NCSX IRIFID IParti II	Number: RFD-14-01	 3R1 RFD Description: Change to C-4 through C- 6 Flange Seats from a Spherical Seat to a Counterbore Seat 		
Initiator: Kevin B Heitzenroeder	owling and Phil Or	Organization: Major Tool/PPPL		
List of Impacted I Drawing SE141-11		on, MIT/QA Plan, SOW, drawing, etc.)		
Cost Impact: (If n None realizable;th time.		r this change is to save machining and inspection		
Machining and ins is expected to save conformance cond spherical seats on (lapping at PPPL to Quality Impact: (several hours of machin itions – it was not possion C1 and C2. These were prectify. If none, so state):	is much easier to perform than a spherical seat. This ning and inspection time and expected to avoid non ble to achieve the tolerances required for the accepted "as is" but will require time –consuming

NCSX RIFID	Number: 14-013R1		RFD Description: Change to C-4 through C-	
IParrit III			6 Flange Seats from a Spherical Seat to a Counterbore Seat	
RLM: Brad Nelso	n/Wavne	Organiz	vation: PPPL	
Reiersen for BEN				
Impact on Interfaces with Other WBS Elements/Items: (If none, so state): NONE				
RLM Recommendation:				
Approve Do Not Approve				
Additional remarks:				
See at

C-4 Counterbore Seat (Typical) Detail Sketch

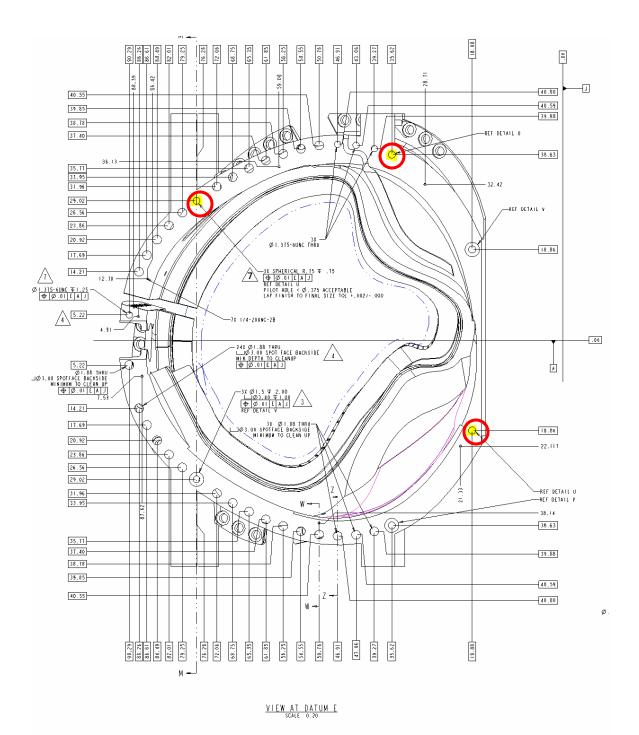
-	ed For: (Specification, MIT/QA Plan, SOW,		
sketches, etc. as ne		ted: (Use continuation pages, e-mails, letter, fying information as appropriate to support deviation		
sketches, etc. as ne request.): During technical r encountered mach that consideration C-3 casting and fo replacement for th appropriate config should be easier to	eded and include ampli neetings at MTM the v ining and inspecting th be given to changing t r all follow-on castings ne conical seats so that guration (eg, conical se	fying information as appropriate to support deviation week of January 3 rd , MTM identified difficulties he spherical seats on the flanges. MTM requested		
sketches, etc. as ne request.): During technical r encountered mach that consideration C-3 casting and fo replacement for th appropriate config should be easier to Detail Sketch".	eded and include ampli neetings at MTM the v ining and inspecting th be given to changing t r all follow-on castings ne conical seats so that guration (eg, conical se	fying information as appropriate to support deviation week of January 3 rd , MTM identified difficulties he spherical seats on the flanges. MTM requested he spherical seats to conical seats, starting with the . Subsequently, counterbores were suggested as a custom "pucks" could be inserted with an at, conical groove, flat) The counterbored seats See the attached figure "C3 Counterbore Seat

RLM Signature:				
Project Disposition:				
Approved. No ECP required.				
Approved. ECP -042 processed to pickup this change.				
		NCSX S	ystems Engineering Support Manager	
Not Approved. Reason(s) for disapproval:
